# COQUITLAM FIRE RESCUE

## HELIPORT ASSESSMENT

TRAINING TOWER CONSTRUCTION  
HELIPORT CLASSIFICATION & FLIGHT PATHS  
NIGHT OPERATIONS & HELIPORT SIZE

by RGHeliservices Consulting Inc.  
2020-10-26

H-701      H3 FLIGHT PATH

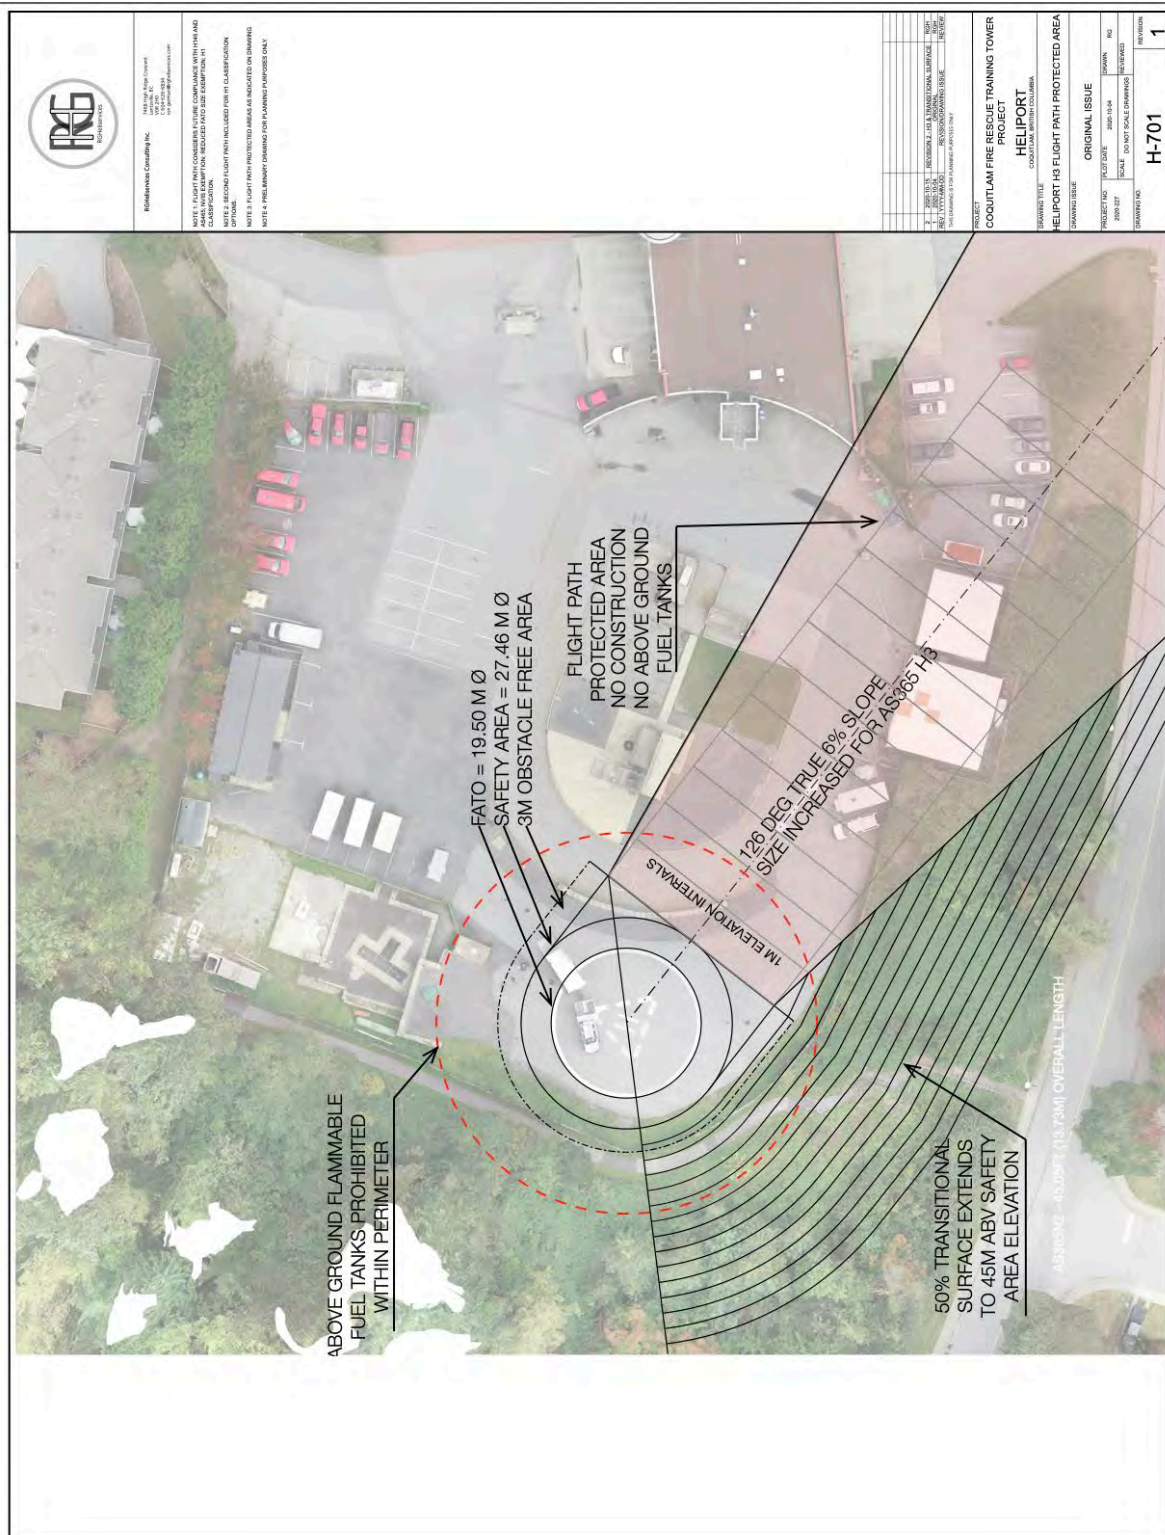
The H3 classification can be maintained unless further development encroaches within the flight path however the classification is not guaranteed. Should Transport Canada take a narrow interpretation of emergency landing areas and determine that there are insufficient to justify the H3 classification, a switch to H1 could occur. Planning should commence now to include two opposing H1 flight paths in addition to the H3 (refer to Appendix A drawings H-701 & H-702). This would improve safety of flight operations.

**RECOMMENDATION #5:** *Design two opposing H1 flight paths to compliment the additional H3 flight path.*
